DESCRIPTION AND SAFETY ANALYSIS  
OF PROPOSED CHANGE NPF-10/15-200

This is a request to revise Technical Specification (TS) 3/4.1.2.1, "Boration Systems - Flow Path - Shutdown," TS 3/4.1.2.2, "Boration System - Flow Paths - Operating," TS 3/4.1.2.6, "Boric Acid Makeup Pumps - Operating," TS 3/4.1.2.7, "Borated Water Source - Shutdown," TS 3/4.1.2.8, "Borated Water Source - Operating," TS 3/4.5.1, "Safety Injection Tanks," TS 3/4.5.4, "Refueling Water Storage Tank," and Associated Bases.

## DESCRIPTION OF PROPOSED CHANGE NPF-10/15-201 AND SAFETY ANALYSIS

This is a request to revise Technical Specification 3/4.2.4, "DNBR Margin", and 3/4.3.1, "Reactor Protective Instrumentation", and their associated bases.

Figure 3.1-1  
MINIMUM BORIC ACID STORAGE TANK VOLUME AND TEMPERATURE  
AS A FUNCTION OF STORED BORIC ACID CONCENTRATION

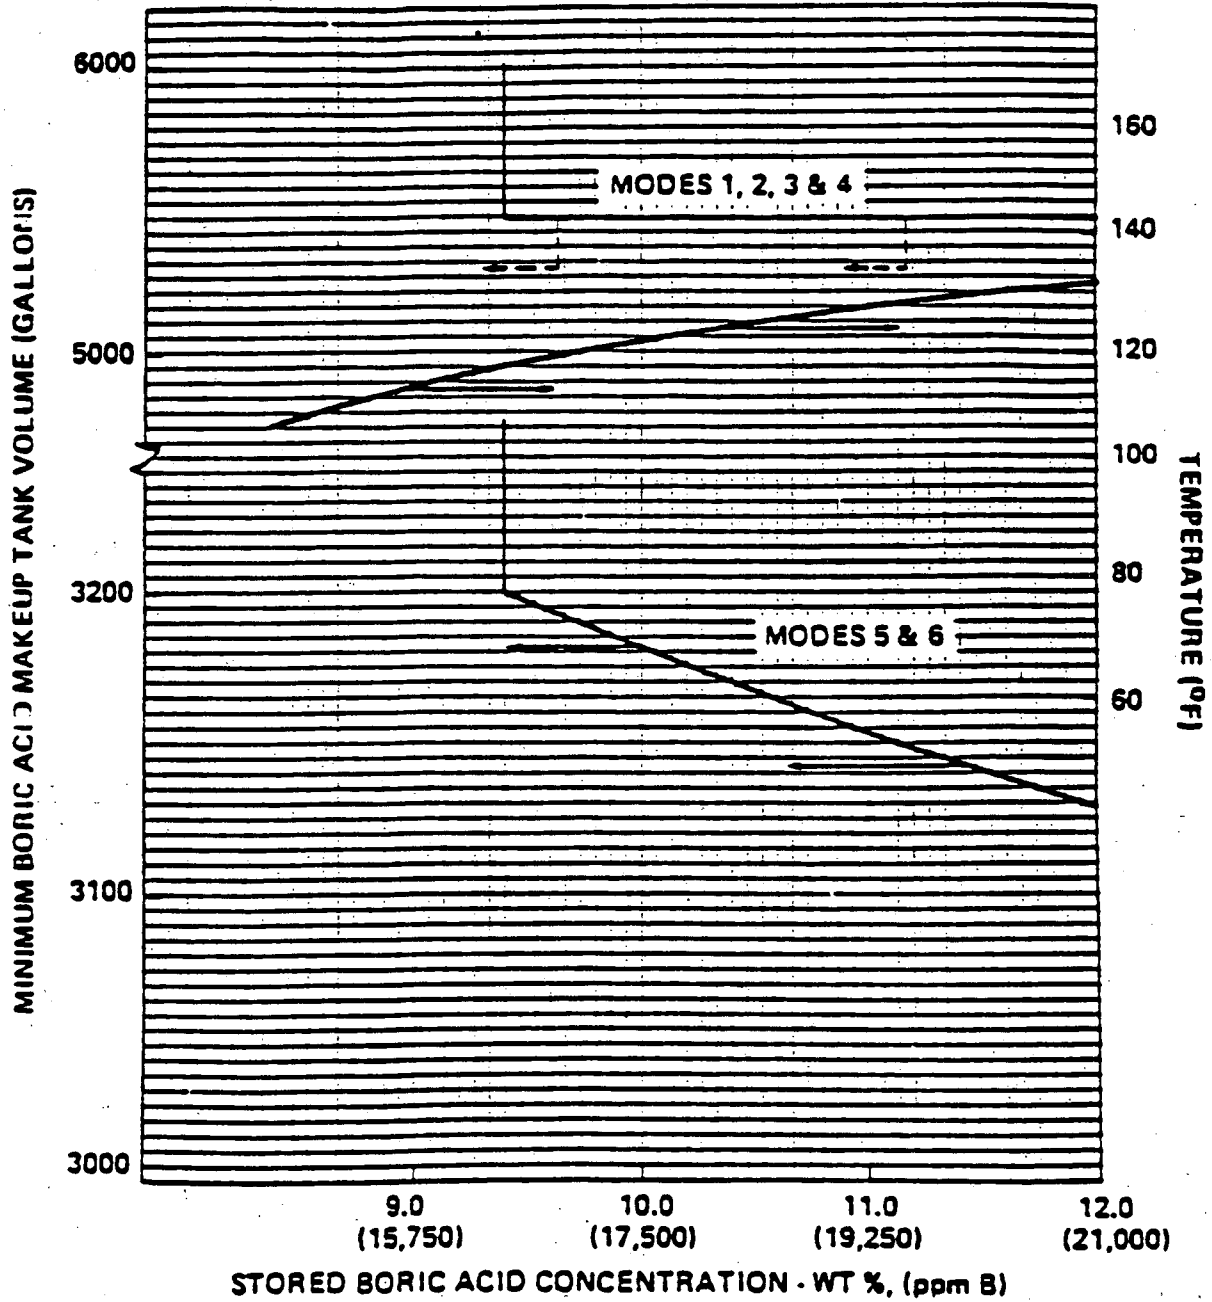
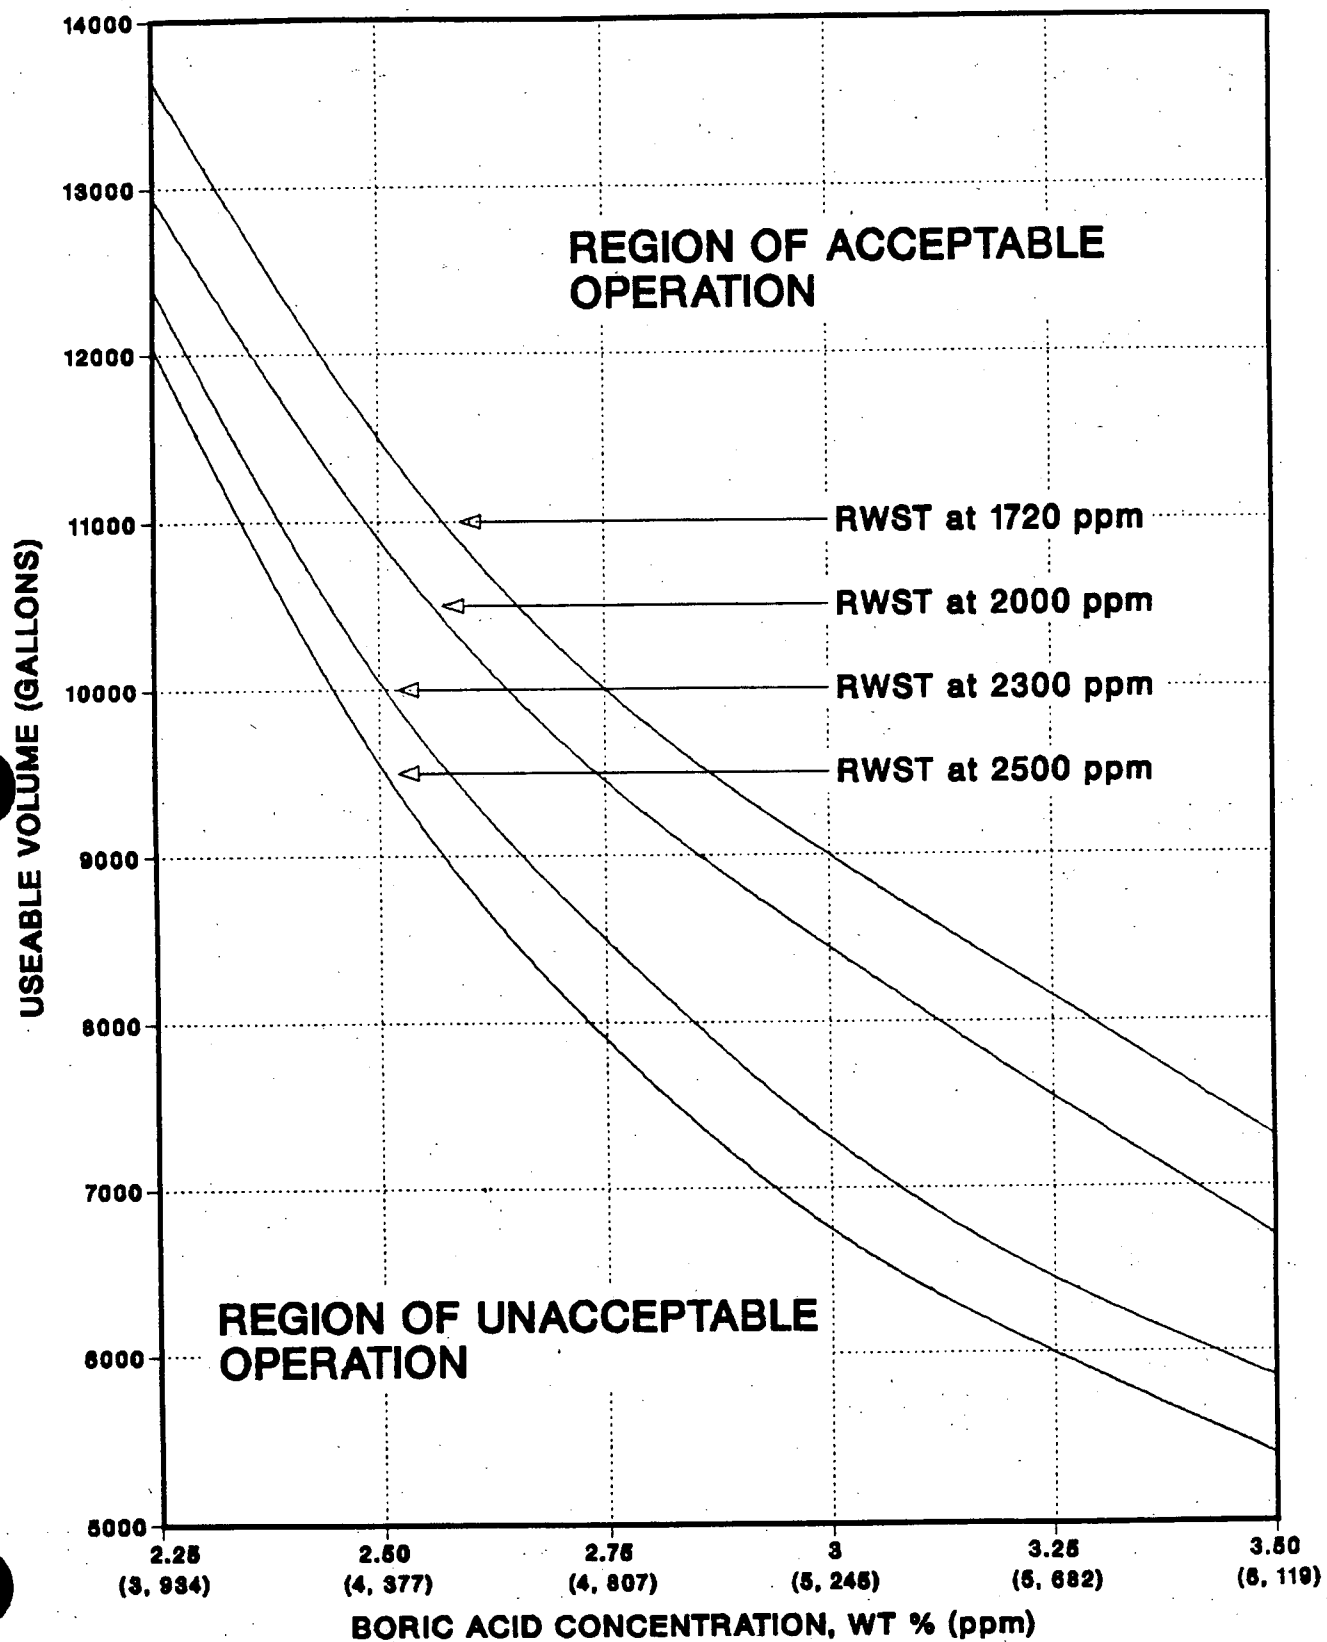
The proposed change will revise TS 3/4.1.2.8 to reduce the concentration range to be maintained in one or both BAMU tanks and to eliminate heat tracing. The range of volumes and concentrations to be maintained in the BAMU tanks is specified in a revised Figure 3.1-1. The revised Figure 3.1-1 will represent the minimum required volume at a given concentration of boric acid to be maintained. The proposed change will allow this volume to be maintained as a combined volume in either or both of the BAMU tanks. The concentration range is approximately 2.25 to 3.5 wt% boric acid. The BAMU tank boric acid requirements depend on the concentration currently maintained in the refueling water storage tank since both are required to provide boration during plant cooldown. Figure 3.1-1 incorporates four curves which represent the minimum boric acid volume required from BAMU tanks for a given RWST concentration.

# REQUIRED STORED BORIC ACID VOLUME AS A FUNCTION OF CONCENTRATION

FIGURE 3.2-1 DNBR OPERATING LIMIT BASED ON CORE PROTECTION CALCULATORS  
 - COLSS OUT OF SERVICE  
 - ONE OR BOTH CEACS OPERABLE

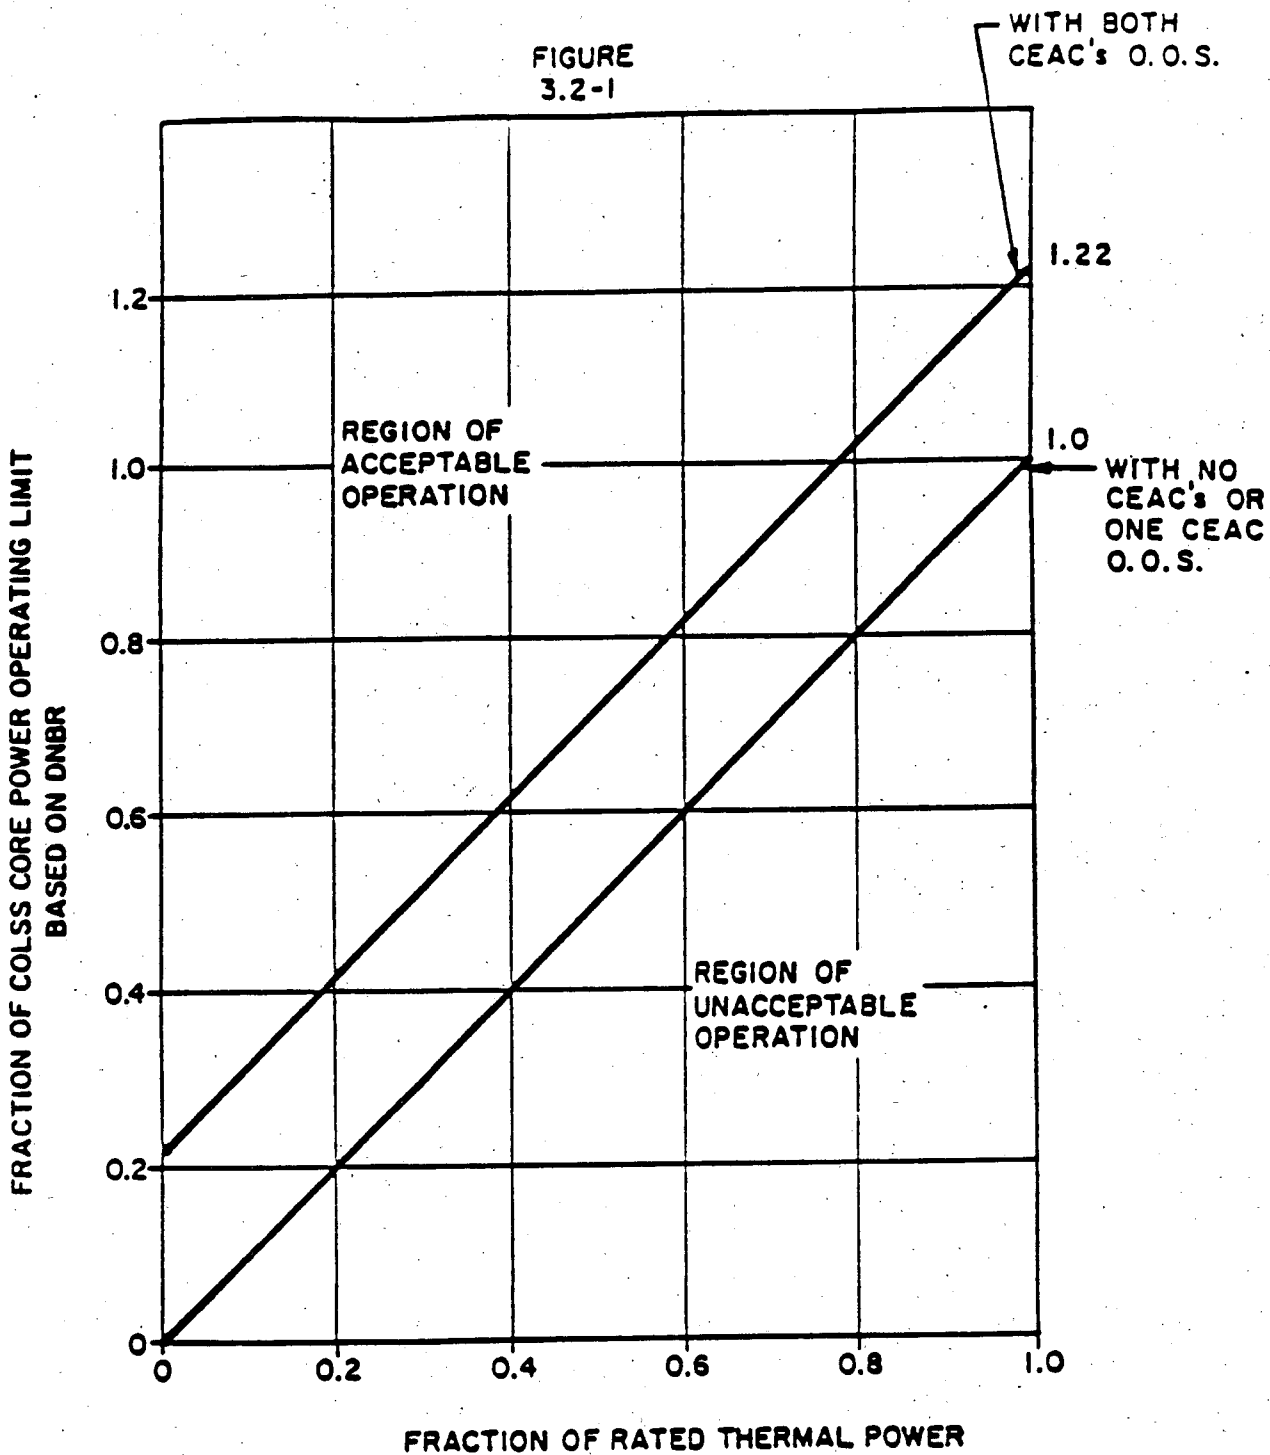
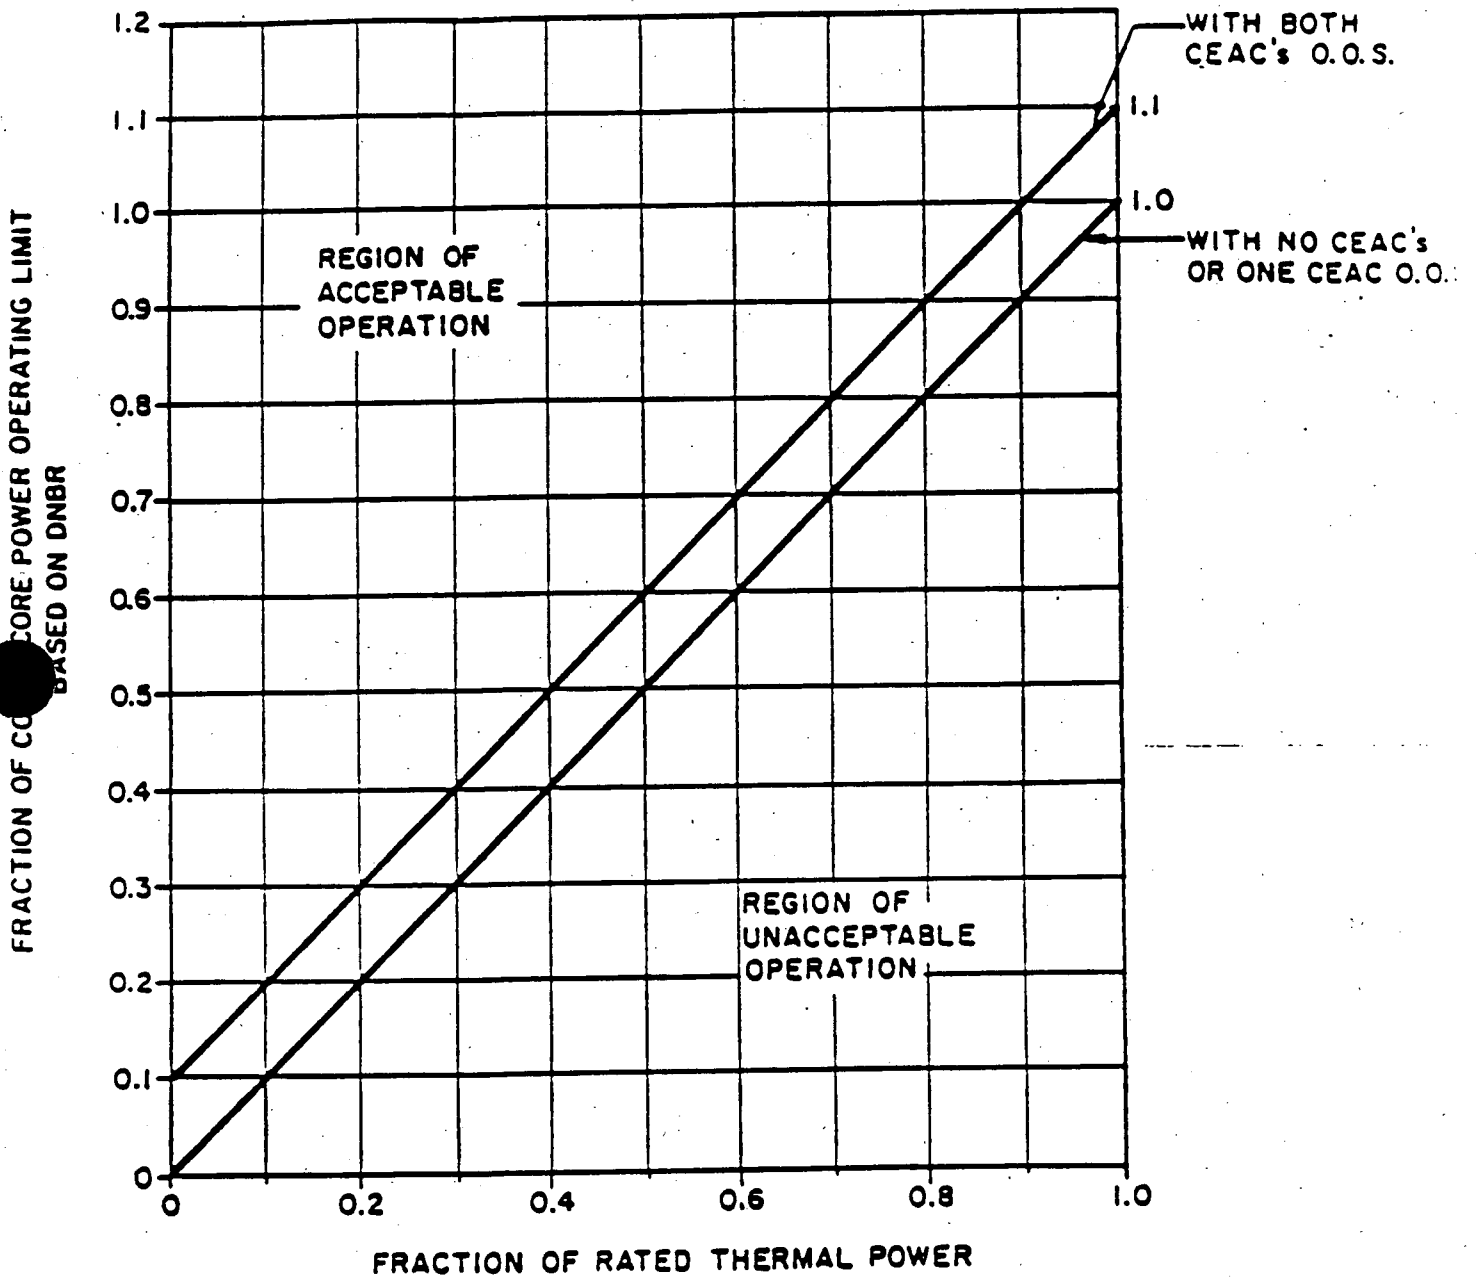
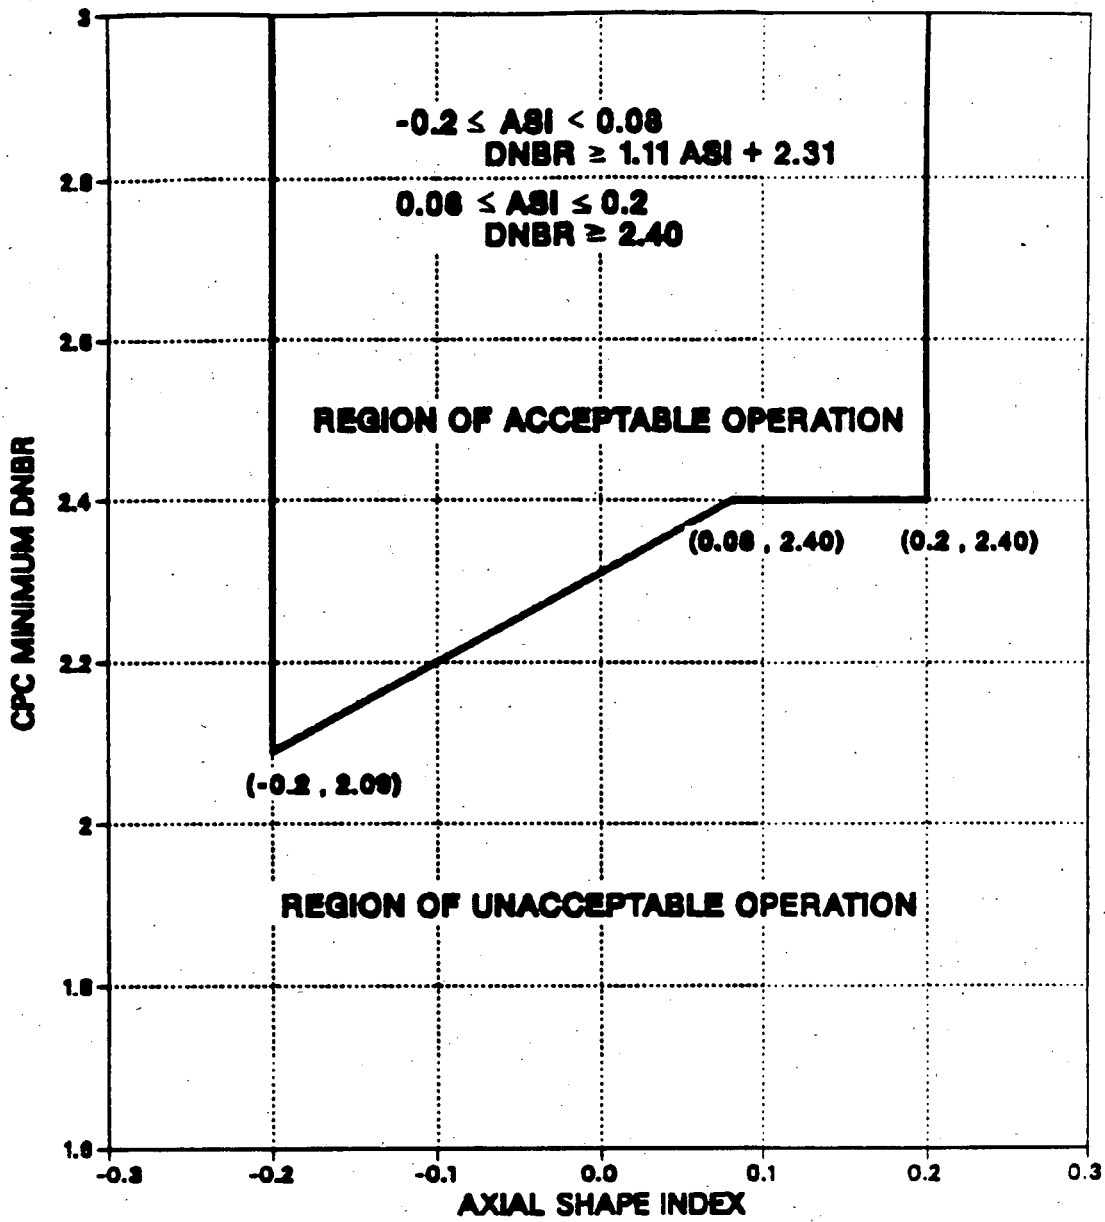
- a) The proposed change revises Figures 3.2-1, "DNBR Operating Limit Based on COLSS", Figure 3.2-2, "DNBR Margin Operating Limit Based on Core Protection Calculators (COLSS out of service, with power greater than or equal to 80% of rated thermal power)", and Figure 3.2-3, "DNBR Margin Operating Limit Based on Core Protection Calculators (COLSS out of service, with power less than 80% of rated thermal power)". Specifically, Figure 3.2-1 shows the minimum calculated Power Operating Limit (POL) based on DNBR for a given reactor power level. Provided that the COLSS POL is greater than that required by Figure 3.2-1 for a given reactor power, the plant is operating in the region of acceptable operation. The existing Figure 3.2-2 defines the required minimum DNBR margin for reactor operation at greater than or equal to 80% power. Figure 3.2-3 defines the required minimum DNBR margin for reactor operation at less than 80% power. The proposed change to Technical Specification 3.2.4 replaces the existing Limiting Condition for Operation (LCO) with four parts, 3.2.4.a through 3.2.4.d. 3.2.4.a and 3.2.4.b replace the existing Figure 3.2-1 with words to the same effect.

3.2.4.a and 3.2.4.b replace the existing Figures 3.2-1 with words to the same effect when COLSS is in service. Additionally, both new figures supplant the existing Figures 3.2-2 and 3.2-3 in compliance with 3.2.4.c and 3.2.4.d when COLSS is out of service. Thus, DNBR will be maintained by 3.2.4.a (or 3.2.4.c) when either one or both CEAC are operable and by 3.2.4.b (or 3.2.4.d) when neither CEAC is operable. Since the proposed change pertains to a revision of graphic representations in LCO with a set of plain administrative control statements easy for understanding and two consolidated figures for simplification, it is a change within the scope contemplated by Example (1).

- a. Maintaining COLSS calculated core power less than or equal to COLSS calculated core power operating limit based on DNBR (when COLSS is in service, and either one or both CEACs are operable); or
- b. Maintaining COLSS calculated core power less than or equal to COLSS calculated core power operating limit based on DNBR decreased by 13.0% RATED THERMAL POWER (when COLSS is in service and neither CEAC is operable); or
- c. Operating within the region of acceptable operation of Figure 3.2-1 using any operable CPC channel (when COLSS is out of service and either one or both CEACs are operable); or
- d. Operating within the region of acceptable operation of Figure 3.2-2 using any operable CPC channel (when COLSS is out of service and neither CEACs is operable).
